# Access Compliance Report

## Public Rights-of-Way

### (Curb Ramps)

Intersection ID: 10025870	Main Street: ELEVATION_POINT_DR	Cross Street: N/A	Location: NE
ADA ID: C9074276865E	Ramp Type: Perp	Initial Pass/Fail: Fail	Overall Compliance: No
Severity Score: 13.75			
Codes/Mitigation Info/Possible Solution		Field Measurements/Component Compliance

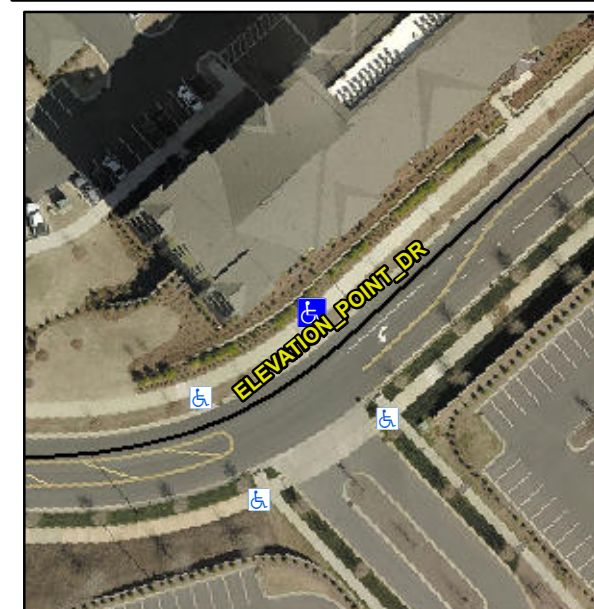
**R304.2.2, R304.5.3**

Compliance	Description	Data	Compliance	Description	Data
N/A	Ramp Length (in)	95.0	No	Ramp Slope (%)	8.6
Yes	Ramp Width (in)	58.0	No	Ramp XSlope (%)	2.7
N/A	Flare Type LT	N/A	N/A	Flare Type RT	N/A
N/A	Flare Slope LT (%)	N/A	N/A	Flare Slope RT (%)	N/A
N/A	Flare Traversable LT?	N/A	N/A	Flare Traversable RT?	N/A
N/A	Landing Length (in)	N/A	N/A	DWS Provided?	N/A
N/A	Landing Width (in)	N/A	N/A	DWS Contrast?	N/A
N/A	Landing Slope (%)	N/A	N/A	DWS Length (in)	N/A
N/A	Landing X Slope (%)	N/A	N/A	DWS Full Width?	N/A
N/A	Landing Curb? (Y/N)	N/A	N/A	DWS Offset (in)	N/A
N/A	Shared Landing?	N/A			
N/A	Gutter Ponding?	N/A	N/A	Gutter Slope (%)	N/A
N/A	Gutter Lip Ht (in)	N/A	N/A	Gutter X Slope (%)	N/A
N/A	Painted X Walk1?	No	N/A	Painted X Walk2?	N/A
	X Walk 1 Direction	To SE		X Walk 2 Direction	N/A
N/A	X Walk 1 Width (in)	N/A	N/A	X Walk 2 Width (in)	N/A
	X Walk 1 Slope (%)	3.2		X Walk 2 Slope (%)	N/A
	X Walk 1 X Slope (%)	2.0		X Walk 2 X Slope (%)	N/A

**Remove & Replace Entire Ramp.**
